PRODUCT/PROCESS CHANGE NOTIFICATION

PCN IPD-IPC/13/8067

SRK2000D : Metal mask change

Figure 1 Updated internal block diagram

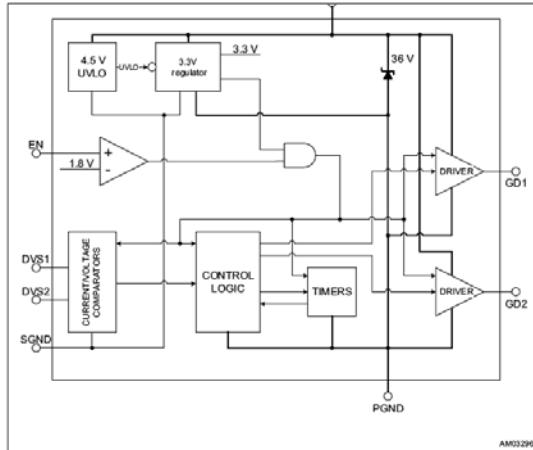
We have removed a residual connection from the internal temperature sensor to the driver section, not reported in the spec. but shown in the internal block diagram, as per the updated internal block diagram (fig.1)
